Access Compliance Report

Public Rights-of-Way

Intersection ID: 45981	Main Street: LAUREL_VALLEY_RD	Cross Street: MASON MILL_PL	Location: SE
ADA ID: 0AB96DC1B152	Ramp Type: PerpDiag	Initial Pass/Fail: Fail	Overall Compliance: No
			Severity Score: 21.25

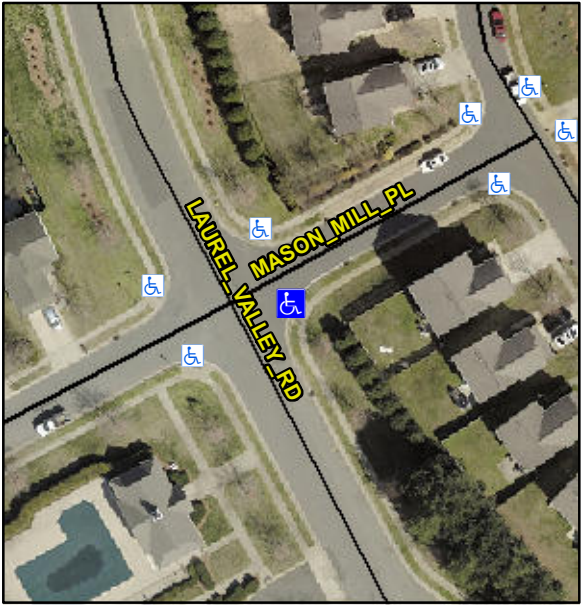
Codes/Mitigation Info/Possible Solution			Field Measurements/Component Compliance		
	Possible Solutions:		Compliance	Description	Data
	Remove & Replace Curb Ramp With Two New Directional Ramps or Equivalent.		Yes	Ramp Length (in)	6.1
			No	Ramp Width (in)	6.3
			N/A	Flare Type LT	N/A
			N/A	Flare Slope LT (%)	N/A
			N/A	Flare Traversable LT?	N/A
			N/A	Landing Length (in)	N/A
			N/A	Landing Width (in)	N/A
			N/A	Landing Slope (%)	N/A
			N/A	Landing X Slope (%)	N/A
<p>Surveyor Notes:</p> <p>N/A</p> <p>PROW/ADA:</p> <p>R304.5.1, R304.5.3</p>			N/A	Flare Type RT	N/A
			N/A	Flare Slope RT (%)	N/A
			N/A	Flare Traversable RT?	N/A
			N/A	DWS Provided?	N/A
			N/A	DWS Contrast?	N/A
			N/A	DWS Length (in)	N/A
			N/A	DWS Full Width?	N/A
			N/A	DWS Offset (in)	N/A
			N/A	Shared Landing?	N/A
			N/A	Gutter Ponding?	N/A
			N/A	Gutter Lip Ht (in)	N/A
			No	Painted X Walk1?	No
			To N	X Walk 1 Direction	To W
			N/A	X Walk 1 Width (in)	N/A

0.9	X Walk 1 Slope (%)	3.7
			5.4	X Walk 1 X Slope (%)	3.3
			N/A	Ramp inside XWalk1?	N/A
			5.3	Road Slope (%)	N/A
			3.8	Road X Slope (%)	N/A
			N/A	Any Obstructions?	N/A
			N/A	Obstruction Type	N/A
			N/A		N/A
			Yes	Surface Condition? (G/P)	Good
